# Planning and Zoning Commission

Thursday, May 2, 2024

## BRIDGE PARK, BLOCK F - THE BAILEY MSP 24-049MSP

## Proposed Signs

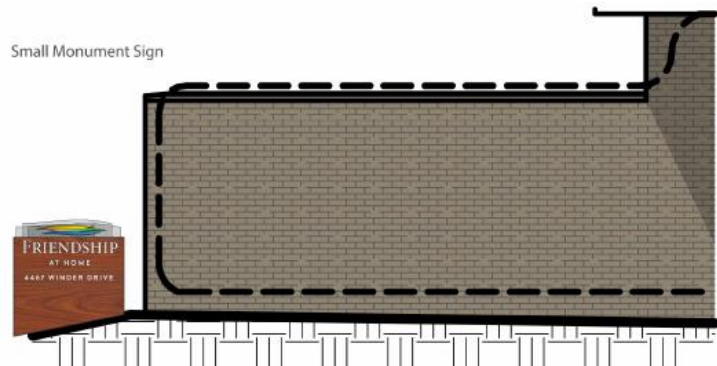
The proposed ground sign is approximately 17 square feet in size and would be located near the screened enclosure northwest of the building at the intersection of Winder Drive and Mooney Street. The height of the sign is approximately 50 inches, with a width of 48 inches. The proposed sign mimics the design of the approved ground sign in the northeast corner of the site, designed with white acrylic push-thru copy, routed alumaboard in a wood finish, and illuminated glass 'fins' above the sign. The logo is featured on the front and back fins, which will be lit from within the cabinet of the sign. The proposed sign is shown approximately 1-foot from the property line along Winder Drive, and approximately 4 feet from the property line along Mooney

Street. The location was selected to provide pedestrian visibility and wayfinding for members of the business to locate the entrance of the building from the Mooney Street parking garage.

The applicant will continue to work with Staff to finalize the landscape plan around the base of the ground sign. Additionally, the applicant should update the site plan to accurately represent the setback of the sign from both streets and the building.

The proposed wall sign is approximately 4 square feet in size and located adjacent to the entrance of the tenant space on the north elevation. It would be fixed to a wall approximately 14 feet forward of the entrance for visibility and wayfinding, at a height of 6 feet to the top of the sign. The sign will be constructed of routed alumaboard, matching the approved and proposed ground signs. This sign replaces the previously proposed projecting sign, which typically is used along sidewalks near the street.

- 1) The applicant continue to work with Staff to finalize the landscape plan around the base of the ground sign; and,
- 2) The applicant update the site plan to accurately represent the setback of the sign from both streets and the building.
